U. FRASERS SPEAKER SAVER + OVER LED

JUNE 1975
 Dan Fraser

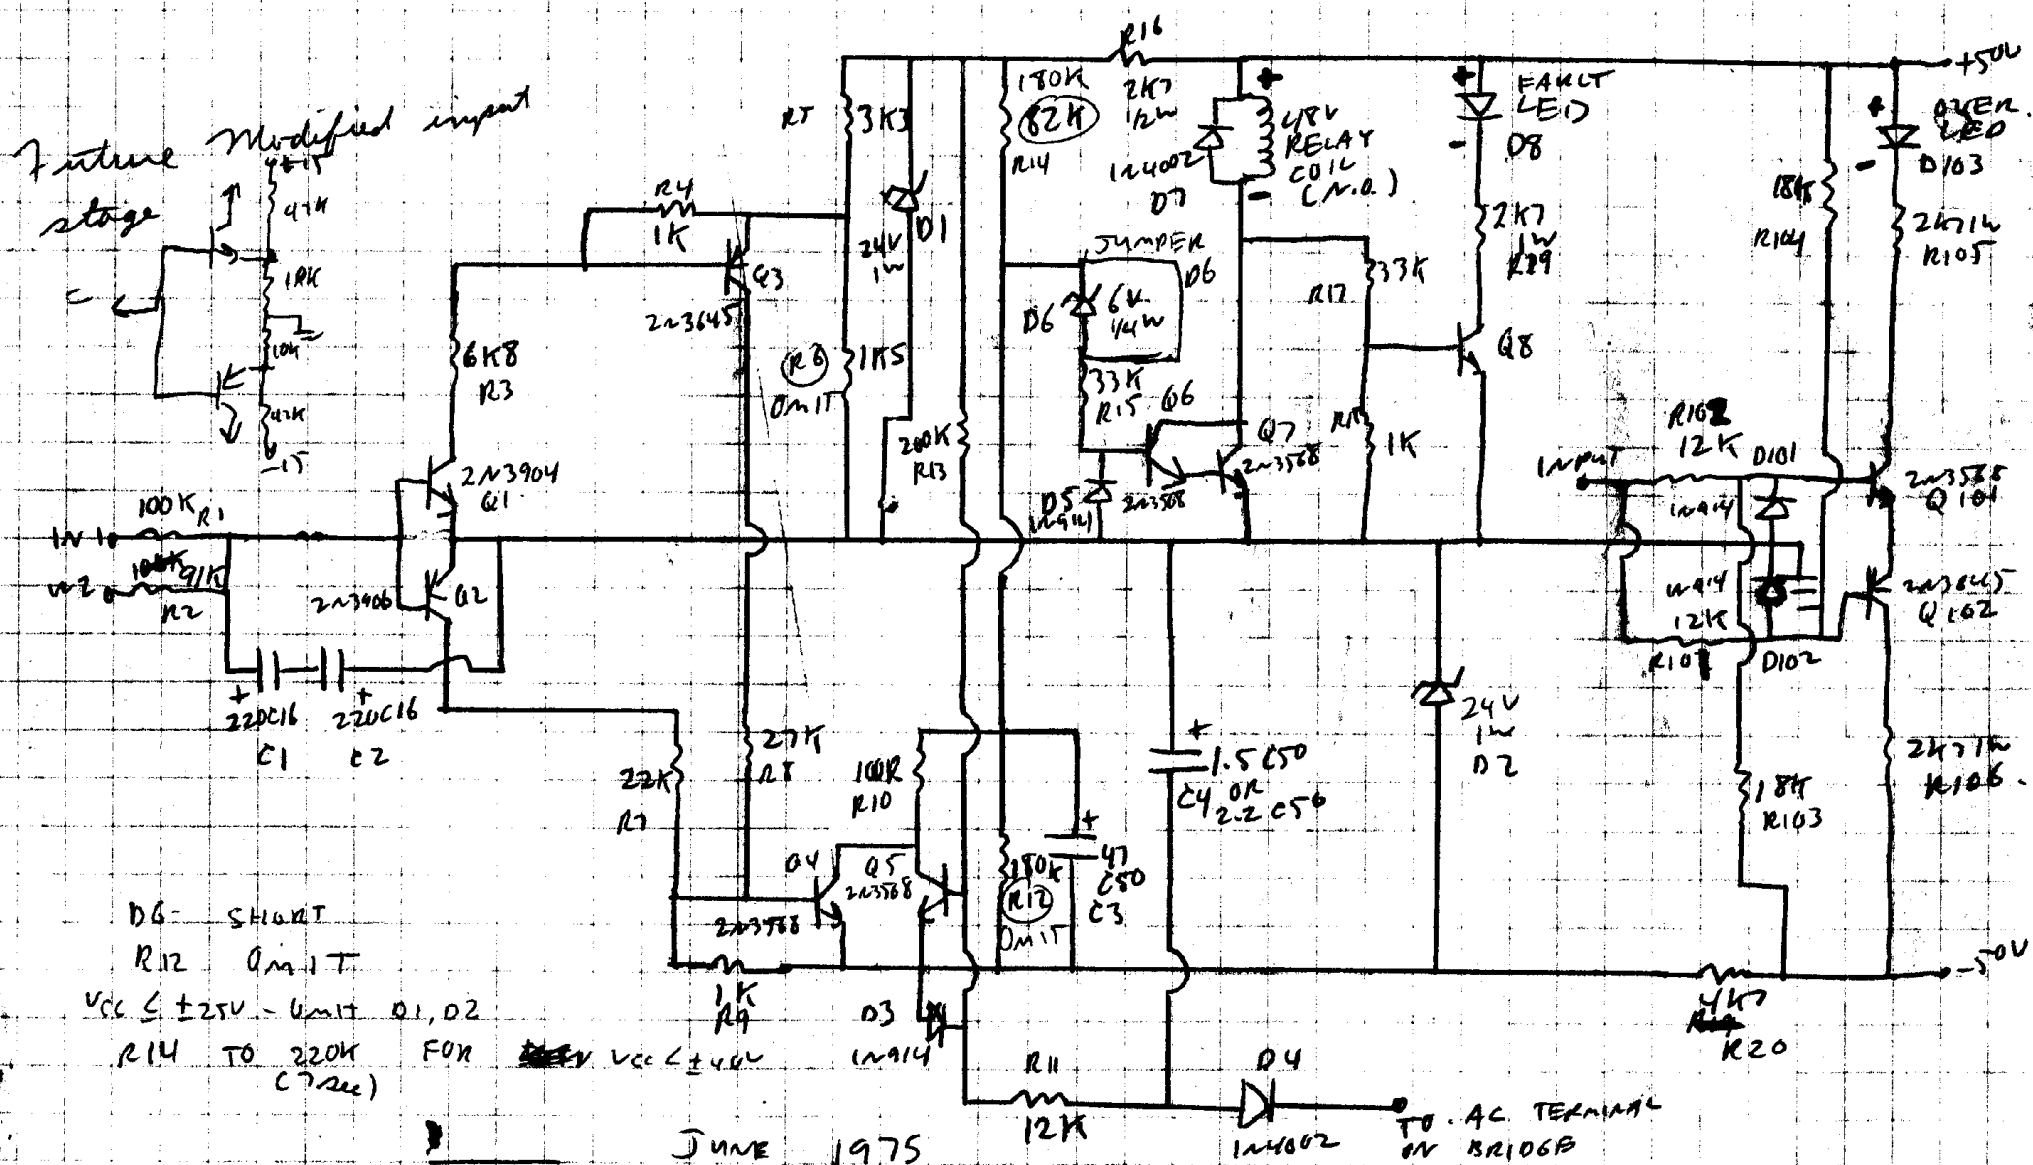
D6 - SHORT
 R12 Omit
 Vcc ≤ ±25V - omit Q1, Q2
 R14 TO 220K FOR ~~Vcc~~ Vcc ≤ ±40V (7sec)
